Site Plan Review

Approval of Infrastructure Plan for 2,590 units on 741.40 Acres

Clarksburg Village Infrastructure Plan

8-02038

The following pages present the Infrastructure Plan:

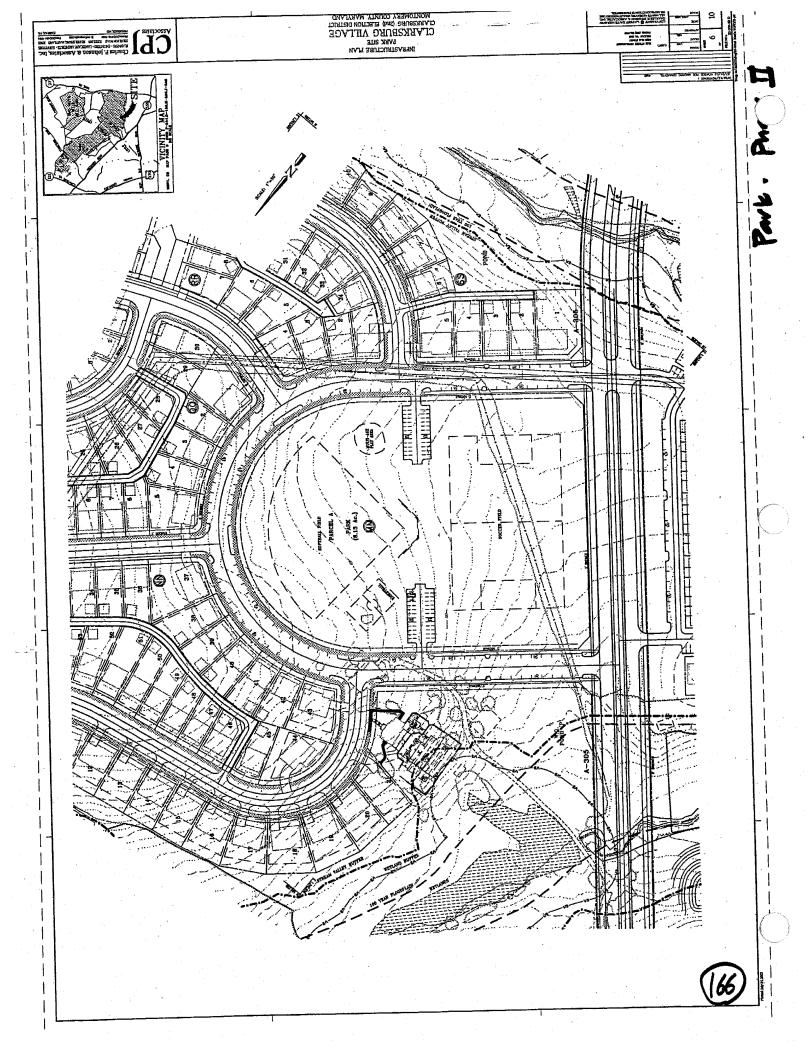
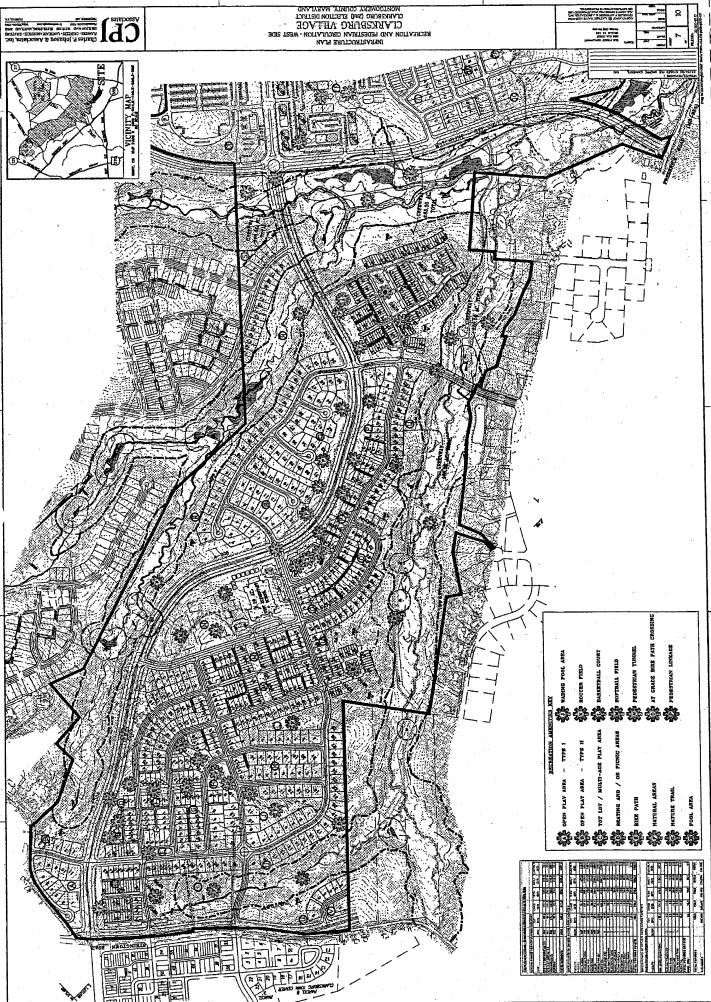
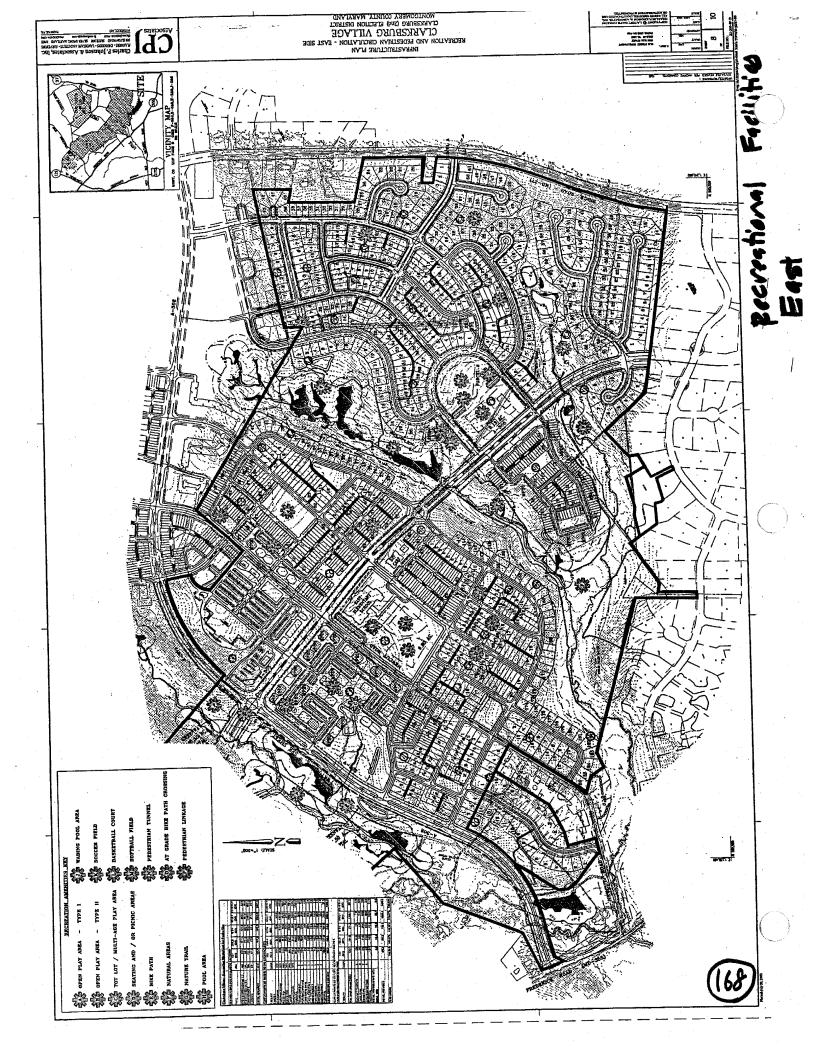
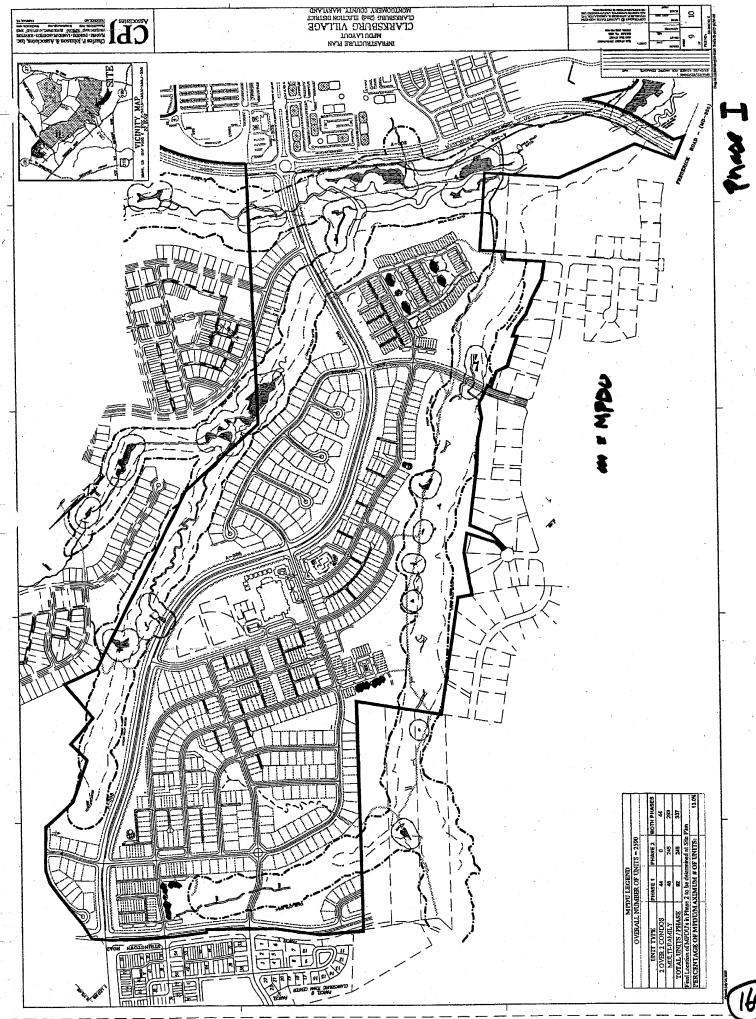
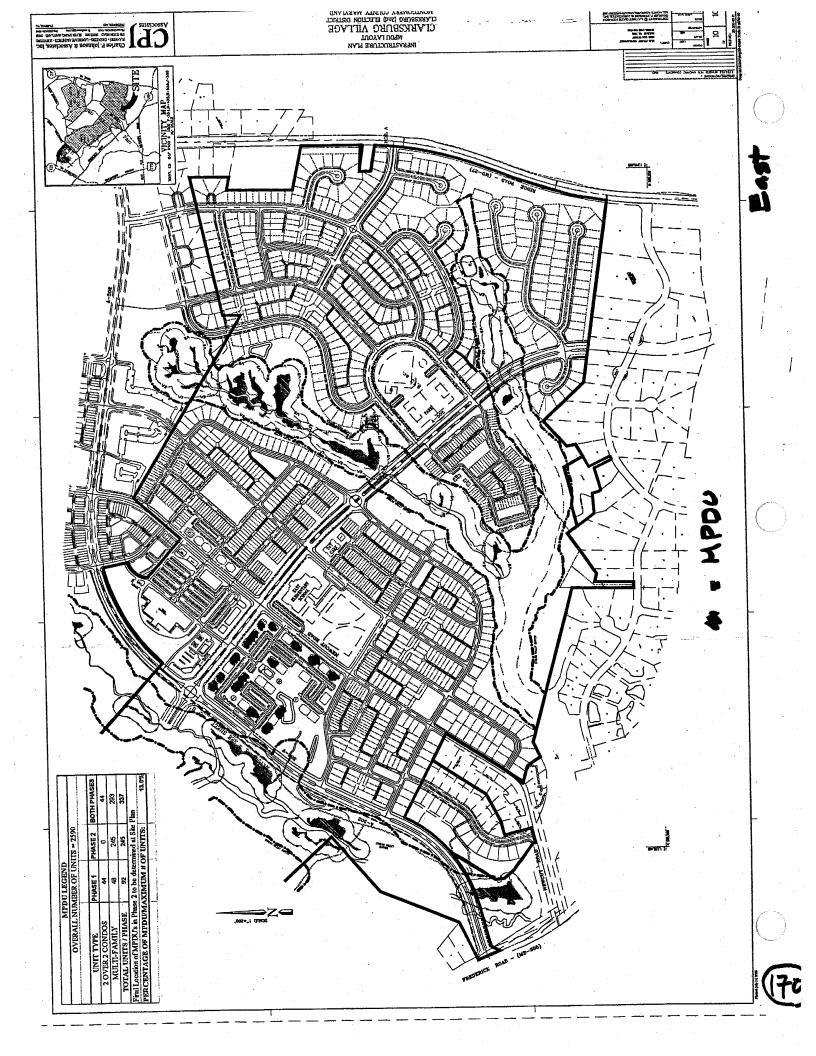
STAFF RECOMMEND ATION: Approval of Infrastructure Plan with the following conditions:

1. Clarksburg Greenway on the property applicant currently owns. The alignment will follow the route established by the Clarksburg Greenway Facility Plan and be

- constructed to park standards and specifications. The Applicant will provide necessary bridges and boardwalk per the Facility Plan.
- 2. Applicant will construct the portions of the hiker/biker trail from Stringtown Road east to Newcut Road and north to the Greenway Village Property that are not on applicant's property, provided that M-NCPPC acquires the ownership or easement rights across the needed property along the trail alignment and funds the proportionate cost to Applicant for construction of these additional sections of trail.

- 3. Applicant will construct Foreman Boulevard to allow for a grade separated crossing for the hiker/biker Greenway Trail. The trail crossing should be constructed to accommodate the trail under the road without changing the natural location, configuration or composition of the stream channel, and should be located to minimize flooding of the trail and minimize surface water runoff from the paved trail directly into the stream. Trail crossing to meet the "staff guidelines" as set out in the attached Meeting Summary of March 18, 2002 unless otherwise agreed to by MNCPPC staff and Applicant. Final trail/road crossing details to be submitted to MNCPPC staff for approval. The details of the Greenway Trail crossing of Midcounty Highway will be determined at time of Site Plan. A grade separated crossing will be considered at this location provided environmental concerns can be reasonably accommodated.

- 4. The property within the delineated Clarksburg Greenway along Little Seneca Creek and Little Seneca Tributary will be dedicated to M-NCPPC and the hiker/biker trail constructed or clearly delineated and marked prior to construction of the residences that abut the Greenway. Signage to reviewed and approved by staff. Dedication to be made at time of record plat and boundaries to be clearly staked to delineate between parkland and private property. Dedicated property to be transferred free of trash and unnatural debris.

- 5. Applicant to construct an 8' wide hiker/biker trail to connect from the bike trail along A-305 to the trail system in parkland on the adjacent Greenway Village subdivision.

- 6. The park area marked as Jeane Onufry Local Park will be graded according to the park layout concept plan, surfaced with topsoil, fine graded to a maximum of +/- 6" over 100', and seeded as appropriate for ball field cover. The park will be dedicated to M-NCPPC at time of record plat. Additional recreational improvements to be constructed by Applicant on the park site with Development District funds, must be constructed to park standards and specifications. Specific types of recreation facilities and their arrangement on the park property must be coordinated with, and approved by, M-NCPPC staff.

- 7. Because of the limited size of both the Jeane Onufry Local Park and the school/park site, stormwater quantity management must be provided by Applicant off the park and school sites to accommodate the runoff from the park and school sites.

8. Proposed Schedule for clearing and grading

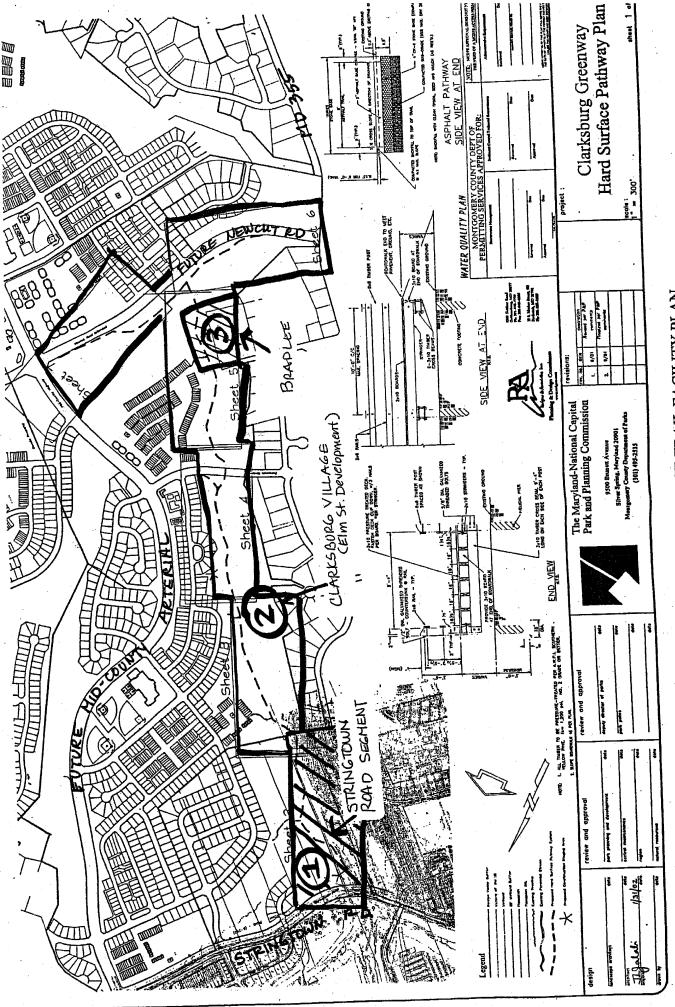
The applicant has provided a sketch for the grading plan for areas to be graded prior to final release of the signature set and is subject to DPS approval. The plans only affect areas within Phase I site plan – future phases may amend this exhibit. Staff recommends the Planning Board approve this advance grading pending coordination with final FCP approval.
